# LAND AT NORTH WEST BICESTER

## TRANSPORT ASSESSMENT VOL 2 (ii) – APPENDIX E - J

Stage 1 Road Safety Audit & Designer's Response

## STAGE 1 RSA DESIGNER'S RESPONSE

## APPENDIX 2: Drawing Showing Problem Locations

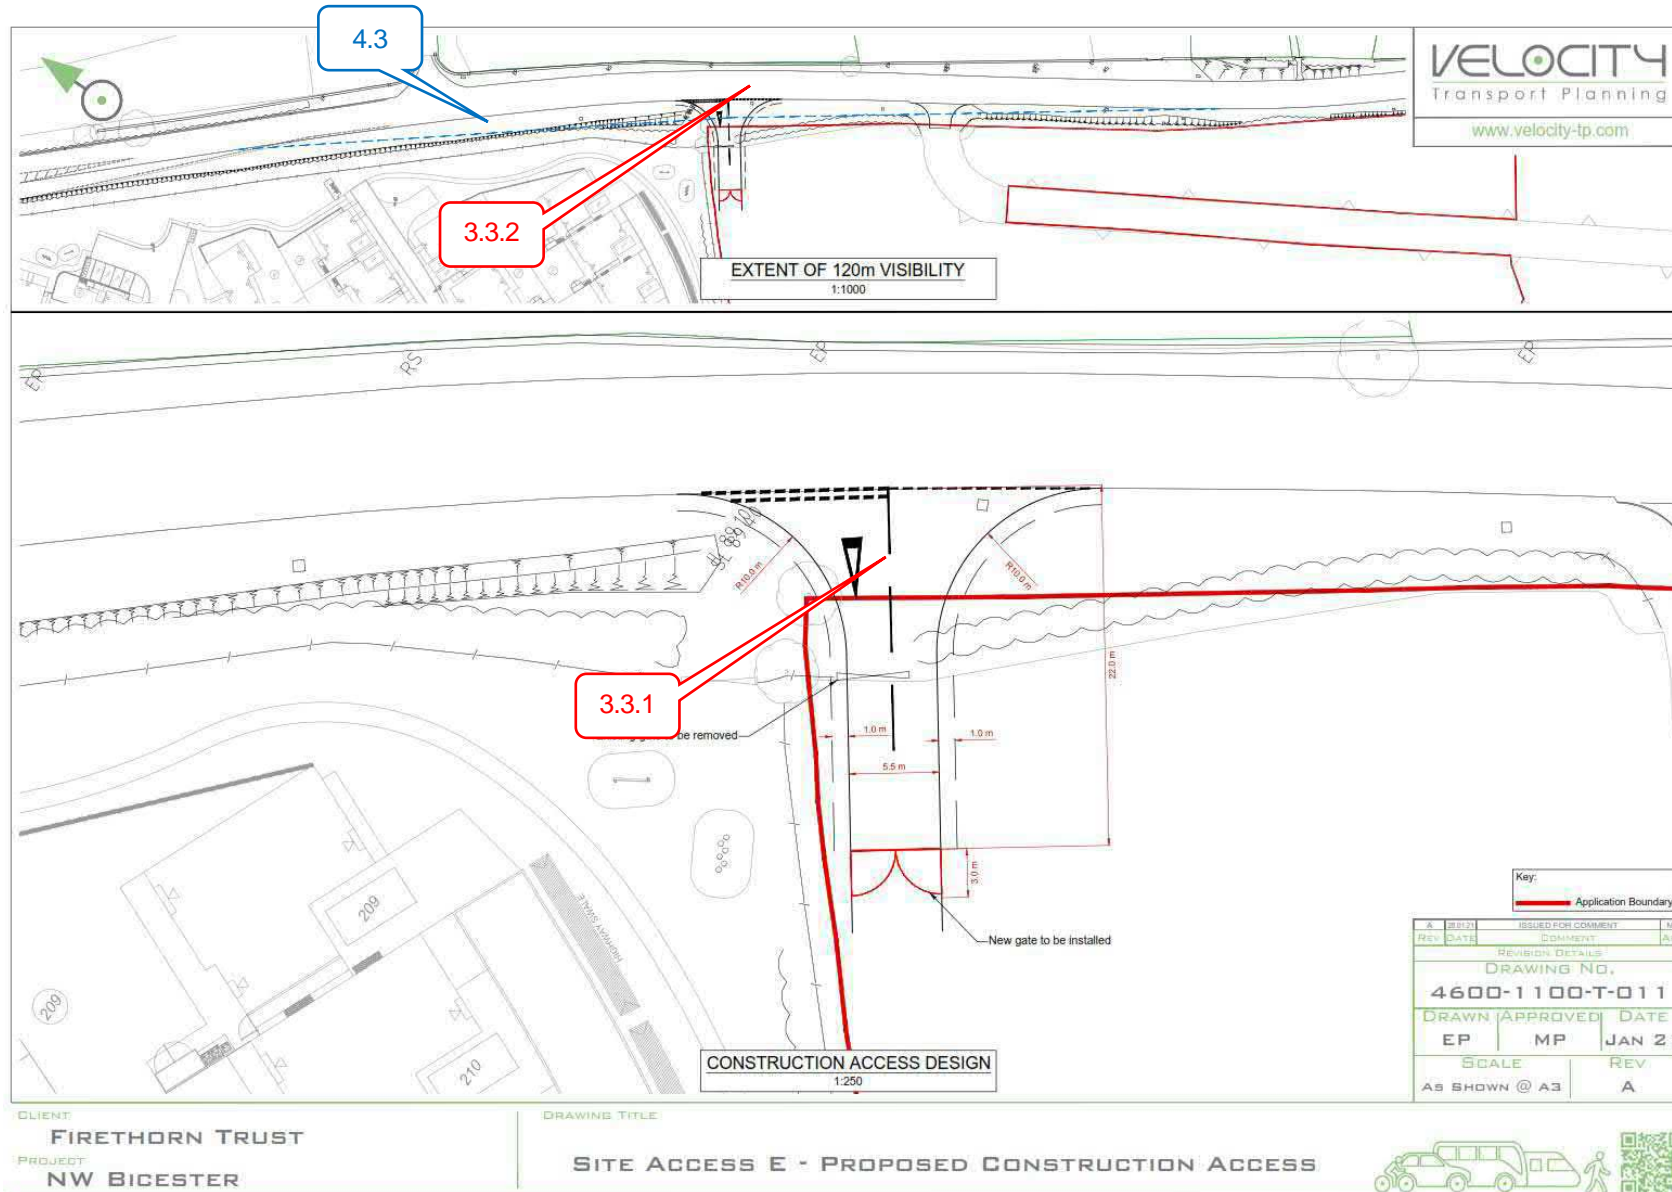
At the existing pedestrian crossing point, there are sections of dropped kerbs, that are unprotected by tactile paving. Sight-impaired pedestrians may not perceive the change from footway to carriageway and inadvertently walking into the path of vehicles.

The existing signing at this location may confuse users, as the 'No Entry' signs appear to prohibit all traffic at this facility. The issue should be discussed with the highway authority for resolution. It would be appropriate to simplify and clarify signing at both ends of the bus only gate facility; an 'exception' plate would be appropriate underneath the 'No Entry' signing.

4.1	<p><b>Location:</b> Site Access A</p> <p>At the existing pedestrian crossing point, there are sections of dropped kerbs, that are unprotected by tactile paving. Sight-impaired pedestrians may not perceive the change from footway to carriageway and inadvertently walking into the path of vehicles.</p> <p>It is acknowledged that this is an existing issue and should be discussed with the highway authority and be resolved, with appropriate remedial measures such as extending tactile paving to cover the dropped kerb areas</p>		It is acknowledged that this is an existing issue, but the layout of the existing crossing facility, including the dropped kerbs and tactile paving, can be revisited as part of the detailed design stage.

4.2	<p><b>Location:</b> At the bus / cycle gate</p> <p>The existing signing at this location may confuse users, as the 'No Entry' signs appear to prohibit all traffic at this facility. The issue should be discussed with the highway authority for resolution. It would be appropriate to simplify and clarify signing at both ends of the bus only gate facility; an 'exception' plate would be appropriate underneath the 'No Entry' signing.</p> <p>The position of the no-entry signage may need to be relocated to suit the new accesses B and C, so that drivers wishing to enter Access B and C do not need drive through the no entry signage.</p>		<p>It is acknowledged that the signage and location of the signage at the existing bus gate might be reconfigured to not only reflect the prohibition of vehicles through the bus gate, with the exception of buses and cycles, but also to simply the arrangement and therefore be less confusing for road users.</p> <p>As part of the detailed design of the site access junctions, amendments to the bus gate, and introduction of the new footway along the western side of the bus gate, the appropriate signage can be agreed with OCC at the detailed design stage.</p>

**DRAWING No.**  
**4600-1100-T-009**

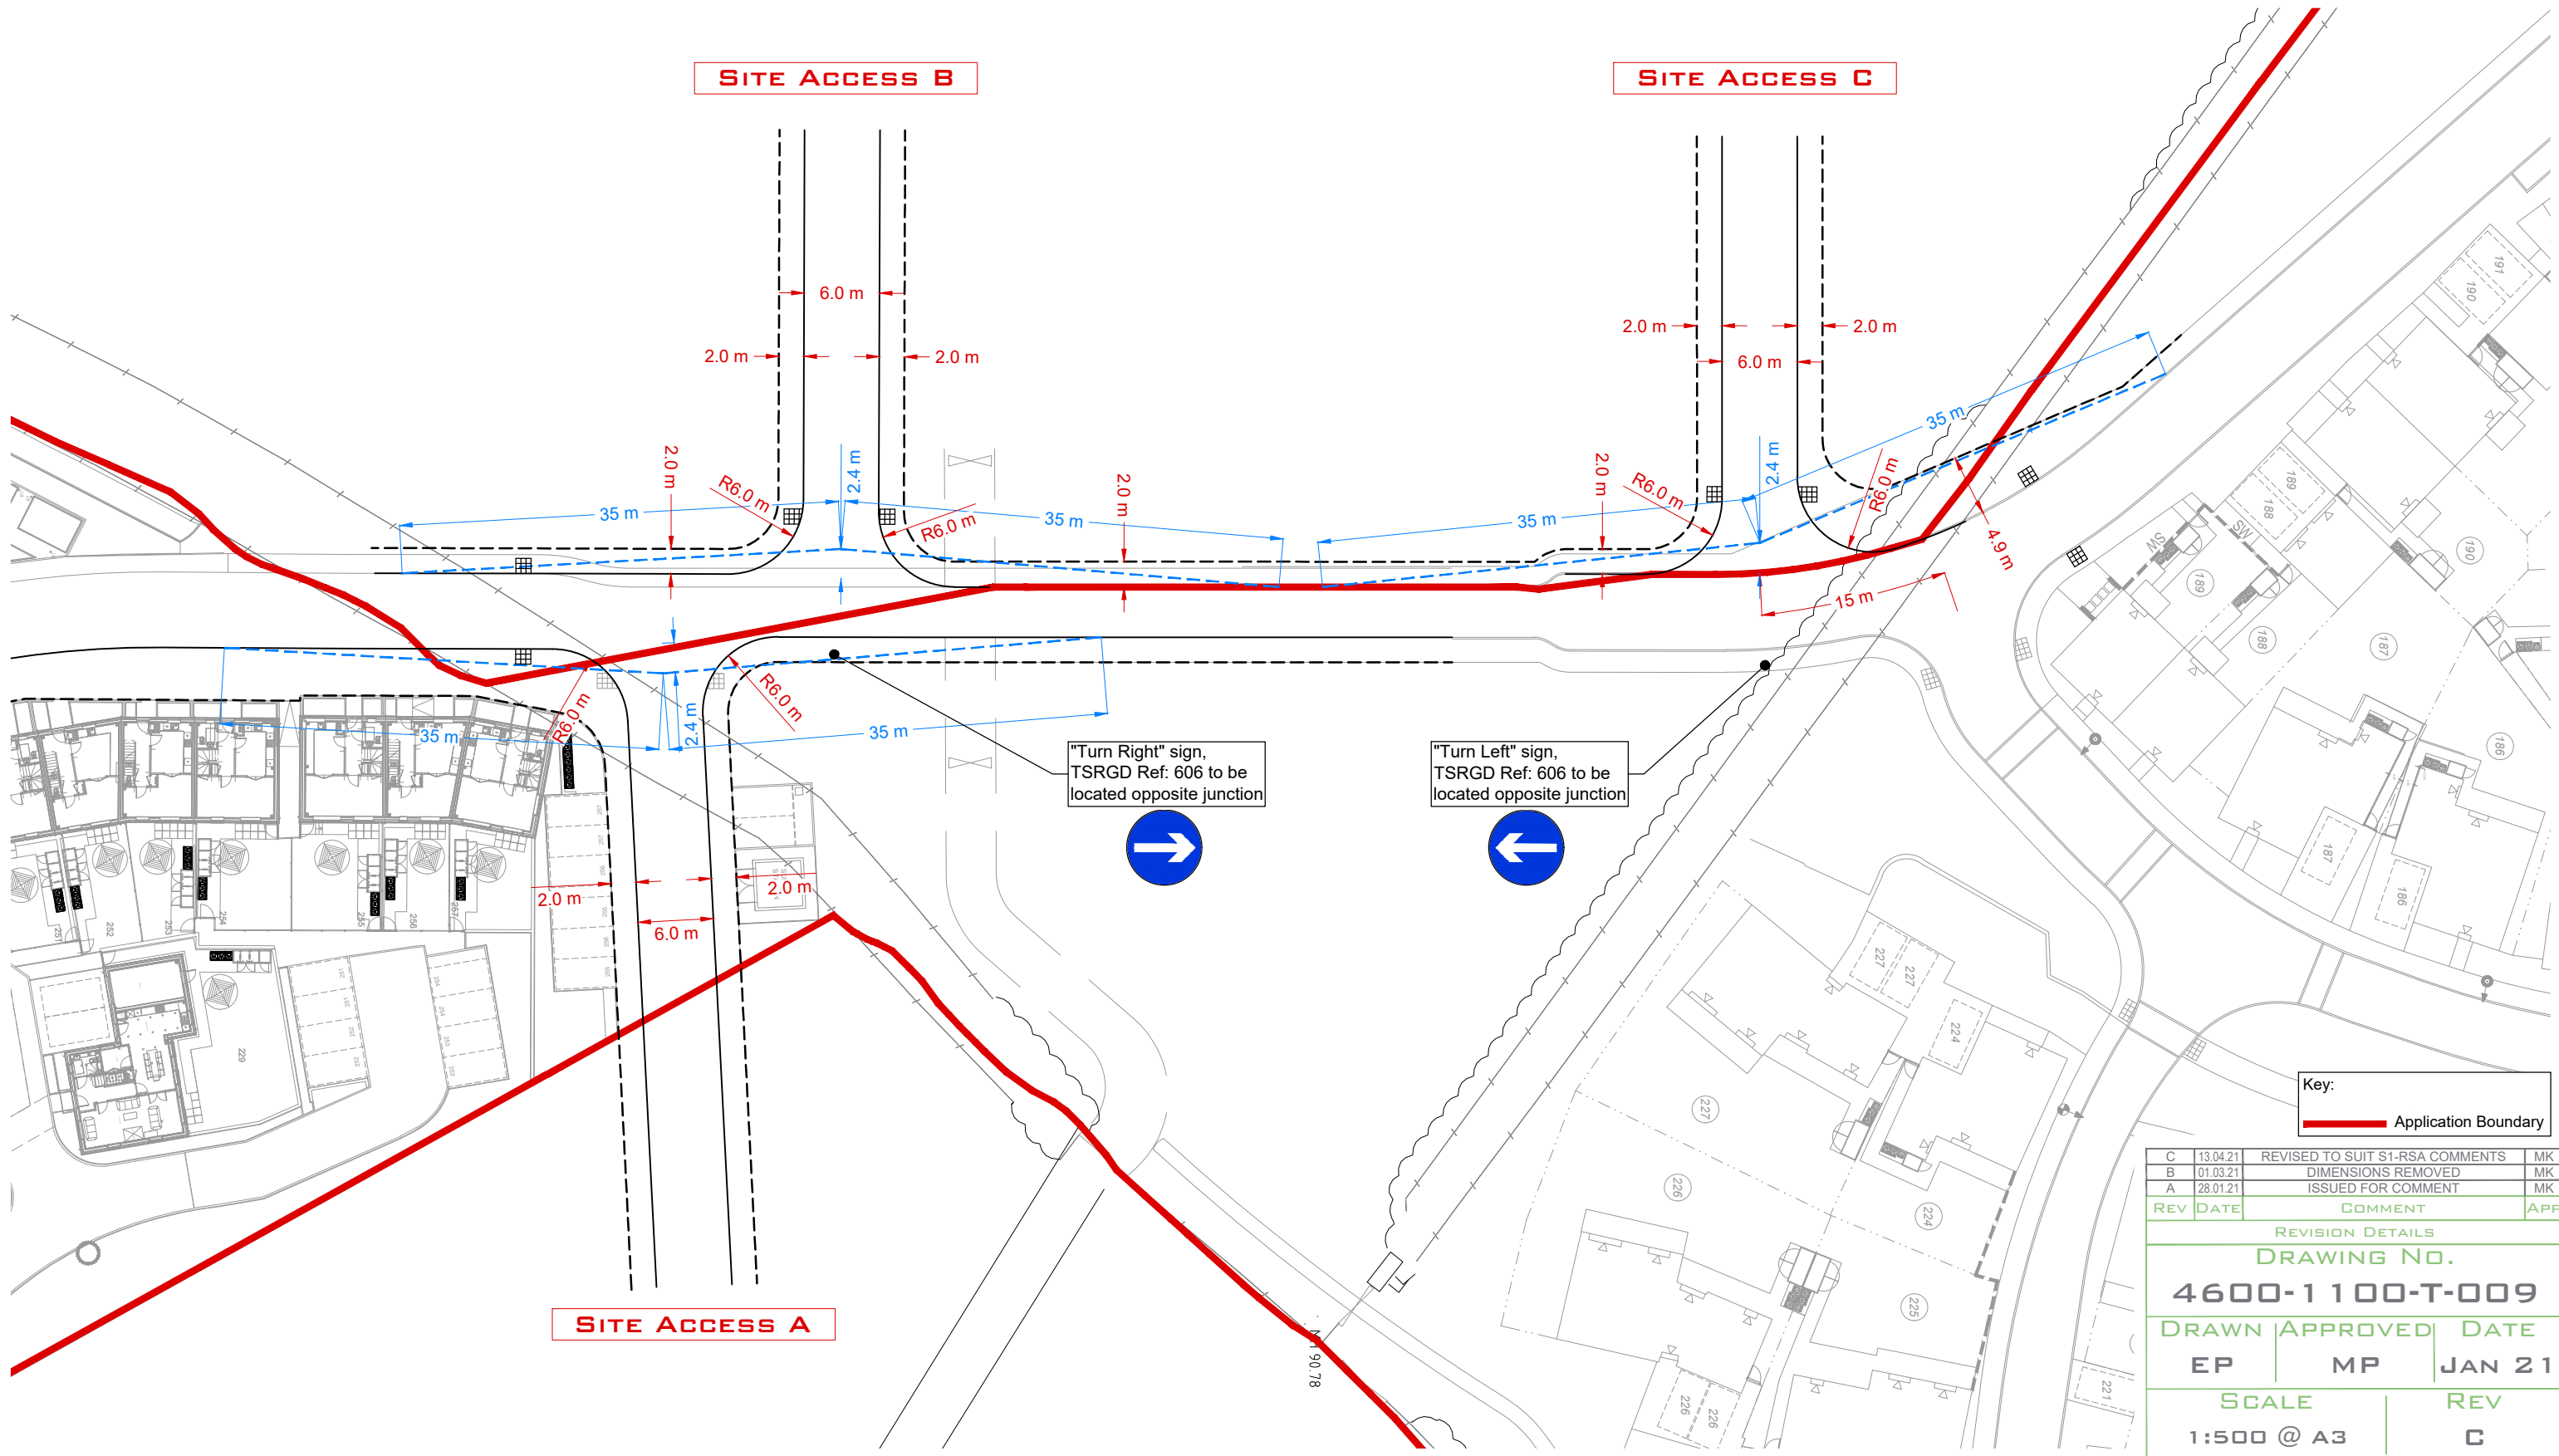
3.1.1	<p><b>Location:</b> Site accesses B &amp; C</p> <p><b>Summary:</b> Tactile paving layout may be confusing and lead to pedestrian to vehicle collisions involving sight-impaired people</p> <p>At the side road crossing points, the tactile paving layout at the junction radii may be confusing for some sight-impaired pedestrians. Some sight-impaired users may find it difficult to align themselves to cross the junction and this may lead to them to walking into the carriageway, or towards upstand kerbs, which may result in pedestrian to vehicle collisions, or trips / falls at kerb upstands.</p>	<p>It is recommended that the crossing points are inset into the side road, to simplify the tactile paving layouts, minimise crossing distances and provide clear crossing alignment.</p>	<p>VTP Drawing <b>4600-1100-T-009 Rev C</b> has been prepared to reflect the Auditor's recommendation.</p> <p>This updated arrangement shows the informal crossing points being relocated, which will include dropped kerbs and tactile paving.</p> <p>The full detailed design of these crossing facilities will be finalised at the detailed design stage.</p>

3.1.2	<p><b>Location:</b> General to the location</p> <p><b>Summary:</b> Lack of pedestrian crossing facilities on pedestrian desire routes may lead to mobility impaired user trips or falls at upstand kerbs</p> <p>It is unclear what routes pedestrians will take east-west across the existing spine road. Should there be a desire to cross the road east-west, the lack of dropped kerb facilities may lead to mobility impaired users, such as older pedestrians or wheelchair users, trips or falls at upstand kerbs.</p>	<p>It is recommended that pedestrian desire routes are assessed and suitable dropped kerb crossing facilities provided, where appropriate.</p>	<p>As per the Auditor's recommendation, the pedestrian desire lines have been assessed and additional informal crossing points identified either side of the existing bus gate.</p> <p>VTP Drawing <b>4600-1100-T-009 Rev C</b> presents the informal crossing facilities.</p> <p>The full detailed design of these crossing facilities will be finalised at the detailed design stage.</p>

It is recommended that the crossing points are inset into the side road, to simplify the tactile paving layouts, minimise crossing distances and provide clear crossing alignment.

REV	DATE	COMMENT	APP
C	13.04.21	REVISED TO SUIT S1-RSA COMMENTS	MK
B	01.03.21	DIMENSIONS REMOVED	MK
A	28.01.21	ISSUED FOR COMMENT	MK

REV	DATE	COMMENT	APP
B	13.04.21	REVISED TO SUIT S1-RSA COMMENTS	MK
A	28.01.21	ISSUED FOR COMMENT	MK
REVISION DETAILS			
DRAWING No.			
4600-1100-T-011			
DRAWN	APPROVED	DATE	
EP	MP	JAN 21	
SCALE		REV	
AS SHOWN @ A3		B

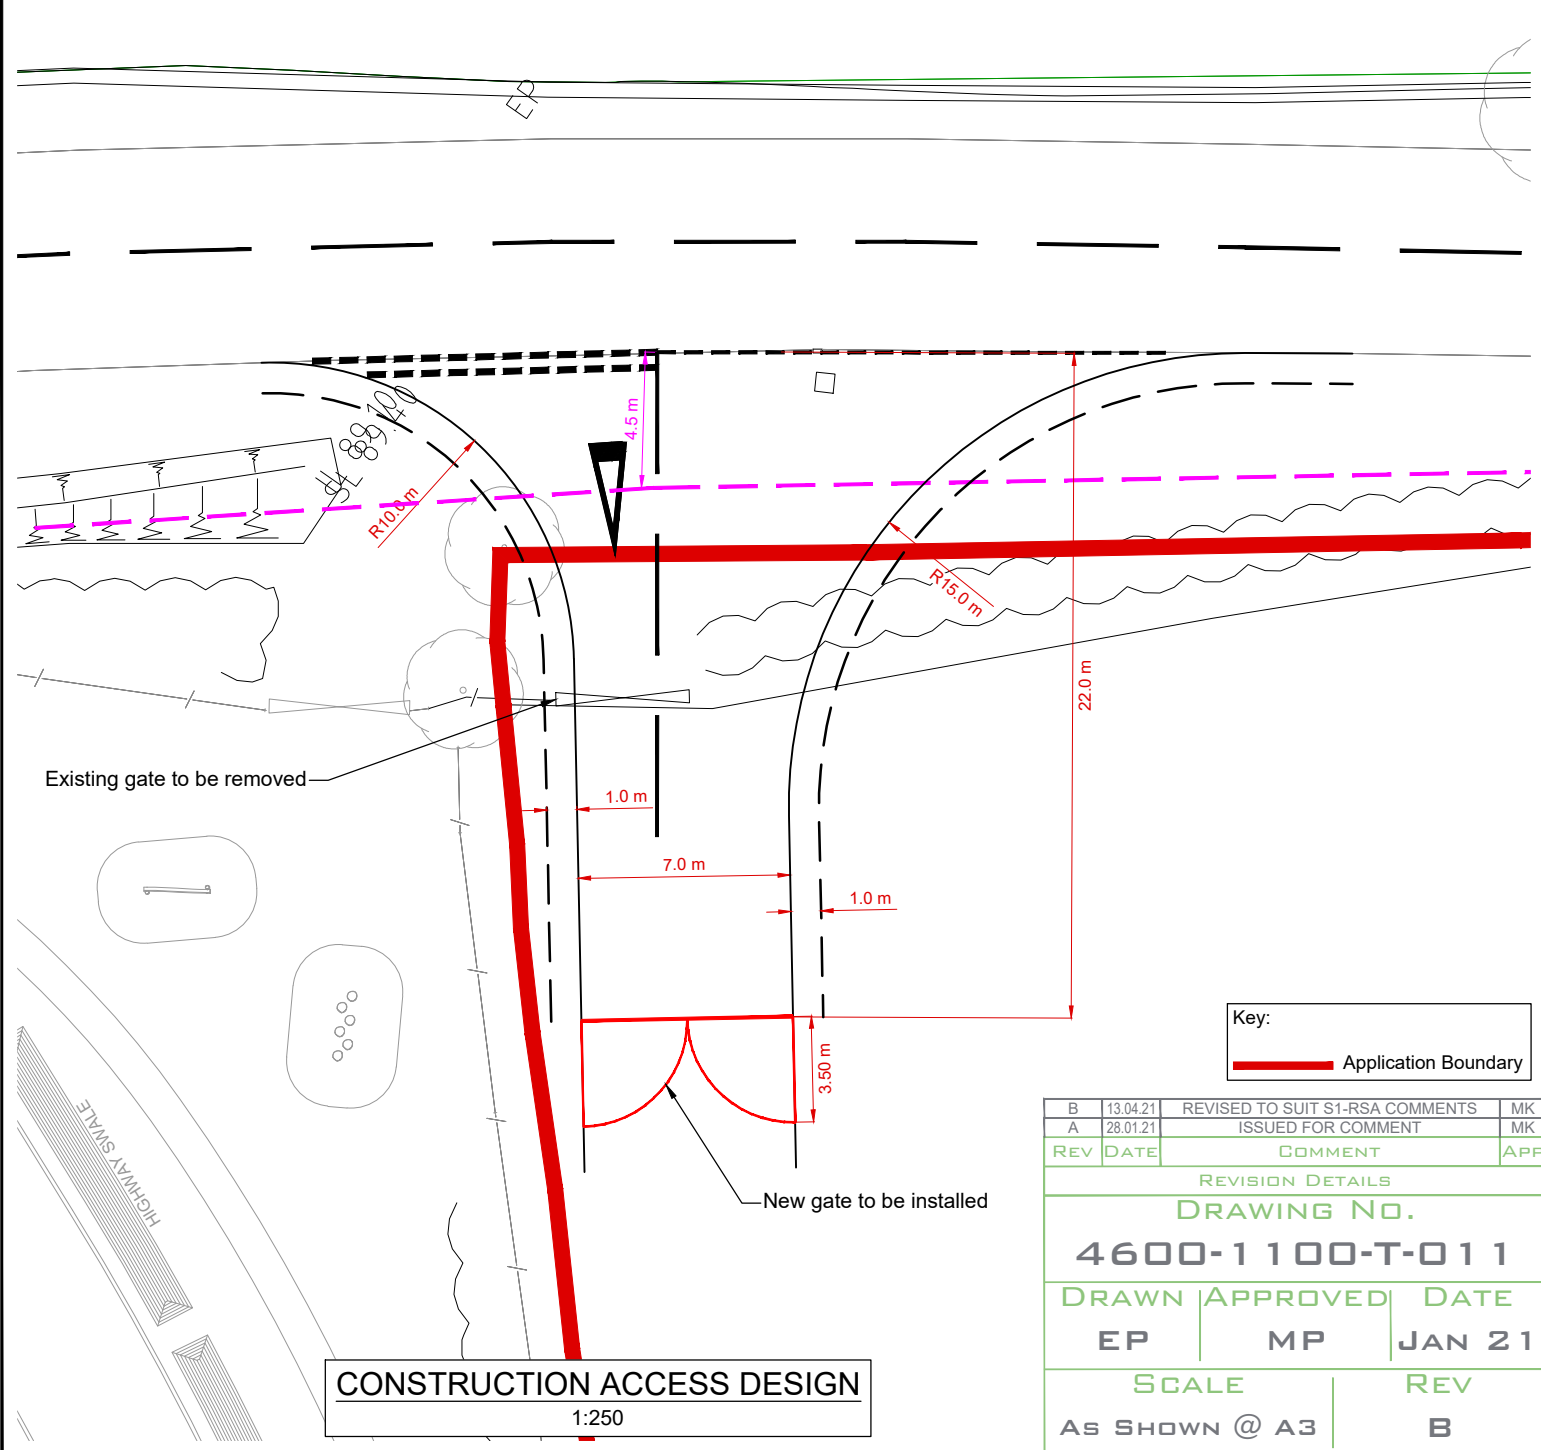
3.3.1	<p><b>Location:</b> At the access</p> <p><b>Summary:</b> Large vehicle swept paths may lead to late braking on the B4100 and shunt type collisions</p> <p>This section of the B4100 is subject to a 40mph speed limit, although there is no street lighting and speed limit repeater signing appears to be widely spaced. By observation, vehicle speeds appeared to be in excess of the posted speed limit. It is unclear whether large construction vehicles will be able to pass each other at the junction mouth and this may lead to construction vehicles stopping suddenly within the main carriageway, with consequent risk of shunt type collisions.</p>	<p>It is recommended that the construction access is sufficiently wide to allow large vehicles to enter and exit the junction simultaneously.</p> <p>It may also be appropriate to provide temporary signing in advance of the construction access, to encourage appropriate vehicle speeds and highlight the likelihood of large slow moving vehicles.</p>	<p>As per the Auditor's recommendation, VTP have reviewed the construction access arrangement and amended this to ensure that simultaneous access can be achieved by 2 large HGVs. VTP Drawing <b>4600-1100-T-011 Rev B</b> presents the revised layout, which now includes the swept path assessment of a large HGV and an indication of appropriate warning signage.</p> <p>The full detailed design of the construction access arrangement will be finalised at the detailed design stage.</p>

3.3.2	<p><b>Location:</b> At the access</p> <p><b>Summary:</b> Muck and detritus on the carriageway may lead to loss of control type collisions</p> <p>Construction activities may lead to deposits of muck and detritus on the B4100, with consequent risk of loss of control type collisions, particularly in wet weather conditions.</p>	<p>It is recommended that adequate measures are introduced to ensure muck and detritus is not deposited on the B4100, which may include effective wheel washing facilities</p>	<p>Prior to the implementation of the construction access junction, a Construction Environment Management Plan (CEMP) will be submitted to and approved by the LPA. This will include details of the appropriate measures to be introduced that will ensure that the carriageway of the B4100 will be kept clear of muck and detritus.</p>

It may also be appropriate to provide temporary signing in advance of the construction access, to encourage appropriate vehicle speeds and highlight the likelihood of large slow moving vehicles.

It is recommended that adequate measures are introduced to ensure muck and detritus is not deposited on the B4100, which may include effective wheel washing facilities.
